TPB Ref.: A/YL-KTS/1062

## Proposed Temporary Warehouse for Storage of Construction Materials and Associated Filling of Land for a Period of 3 Years at Lots 502 RP & 507 S.A RP in D.D. 103, Kam Tin, Yuen Long, New Territories

Our response to the comments of the Transport Department is as follows:

Photo 1

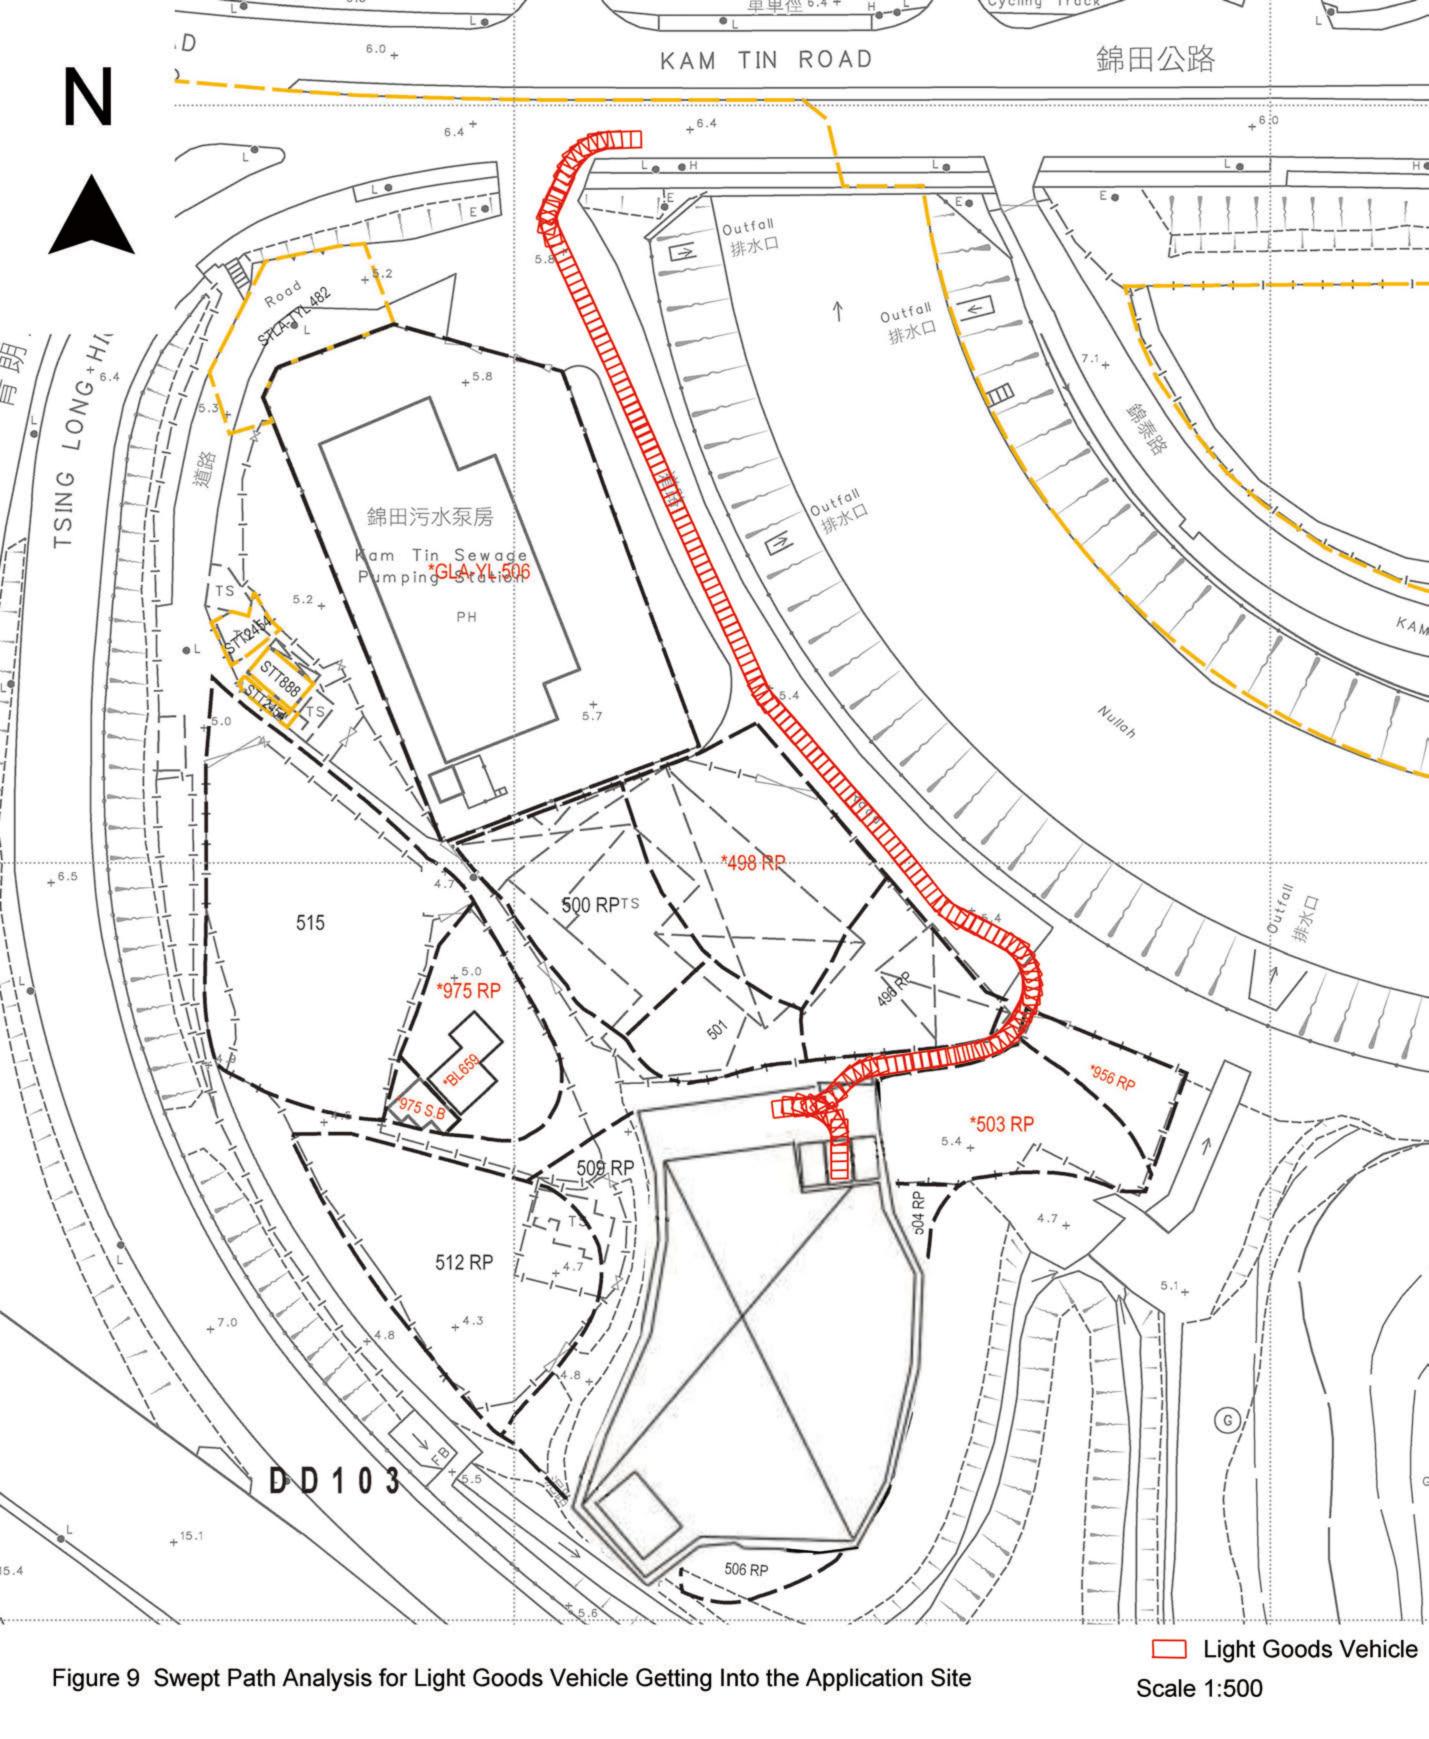
5. colour photos to indicate the current conditions of the existing drainage facilities should be included in the submission. The photos taken locations and angles should be shown on the layout plan;	Noted. Please see the Annex 2 in the attachment. The photo viewpoint is shown in the updated drainage plan.		
<ol> <li>where walls or hoarding are erected or laid along the site boundary, adequate opening should be provided to intercept the existing overland flow passing through the Site;</li> </ol>	100mm opening will be provided at the toe of the site hoarding which is corrugated metal sheets.

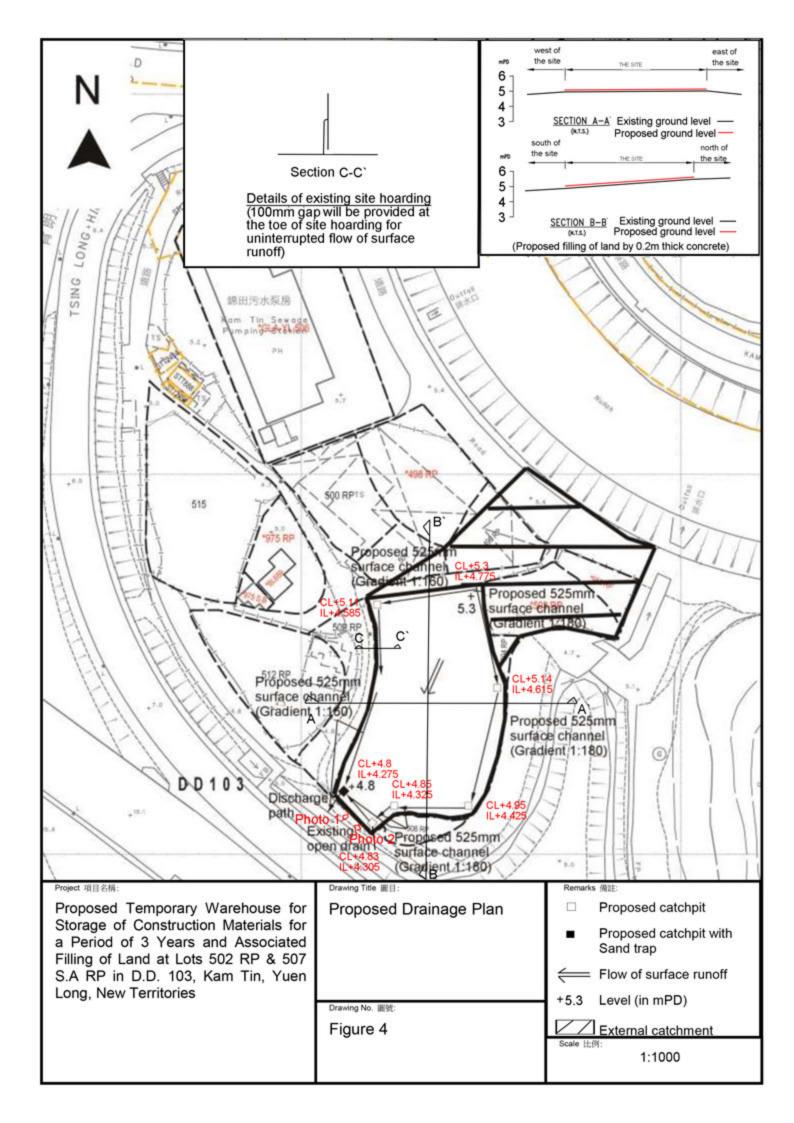
7. cross sections showing the existing and proposed ground levels of the Site with respect to the adjacent areas should be given;	Noted. Please see the updated drainage plan in the attachment.		
<ol> <li>standard details should be provided to indicate the sectional details of the proposed u-channel and the catchpit/sand trap;</li> </ol>	Please see attached drawing.
